Addendum 66 : Regulation No. 67

Amendment 1

UNIFORM PROVISIONS CONCERNING THE APPROVAL OF SPECIFIC EQUIPMENT OF MOTOR VEHICLES USING LIQUEFIED PETROLEUM GASES IN THEIR PROPULSION SYSTEM

FIGURE 1: Containers with longitudinal and circumferential welds, Location of test-pieces"

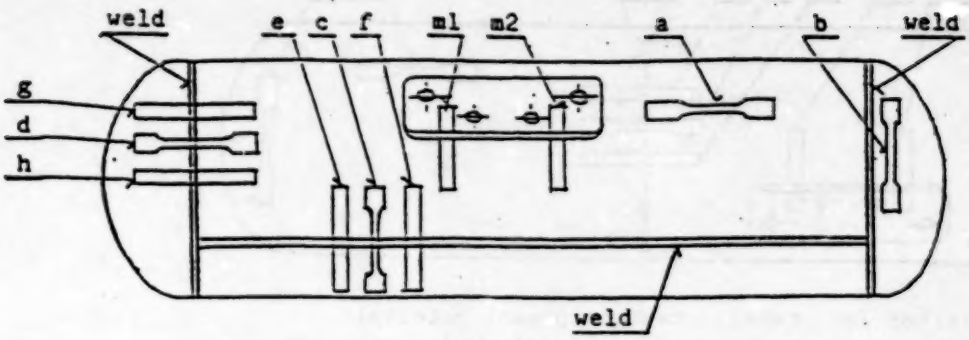
Figure 1, replace by the following:

3.1.2.1.1. Containers with longitudinal and circumferential welds (three sections) on test-pieces taken from the places shown in figure 1 of appendix 2 of this annex:

(a) One tensile test on parent material; the test piece to be taken in the longitudinal direction (if this is not possible, it may be taken in a circumferential direction);
(b) One tensile test on parent material of the bottom;
(c) One tensile test perpendicular to the longitudinal weld;
(d) One tensile test perpendicular to the circumferential weld;
(e) One bend test on the longitudinal weld, the inner surface in tension;
(f) One bend test on the longitudinal weld, the outer surface in tension;
(g) One bend test on the circumferential weld, the inner surface in tension;
(h) One bend test on the circumferential weld, the outer surface in tension; and
- One macroscopic test of a welded section;
(m1, m2) A minimum of two macroscopic tests of valve boss/plate sections in case of the sidewall mounted valves referred to in paragraph 3.4.2. below.

FIGURE 2a: Containers with circumferential welds only and side-mounted valve blocks; Location of test-pieces"

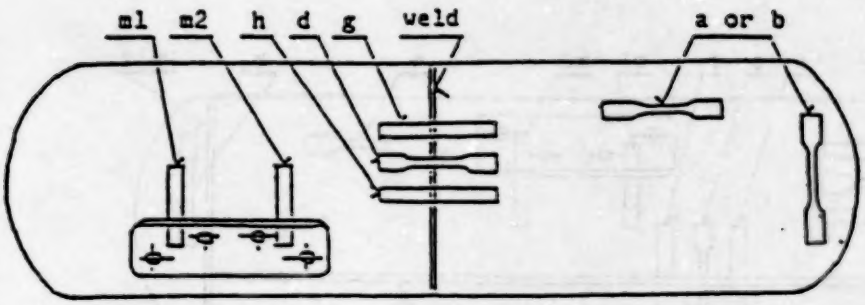
Add new figures 2a and 2b as follows:

3.1.2.1.2. Containers with circumferential welds only (two sections) on test-pieces taken from the places shown in figures 2a and 2b of appendix 2 to this annex:
The tests as specified in paragraph 3.1.2.1.1. above with the exception of (c), (e) and (f) which are not applicable. The test-piece for the tensile test on parent material shall be taken from (a) or (b) as mentioned in paragraph 3.1.2.1.1. above."
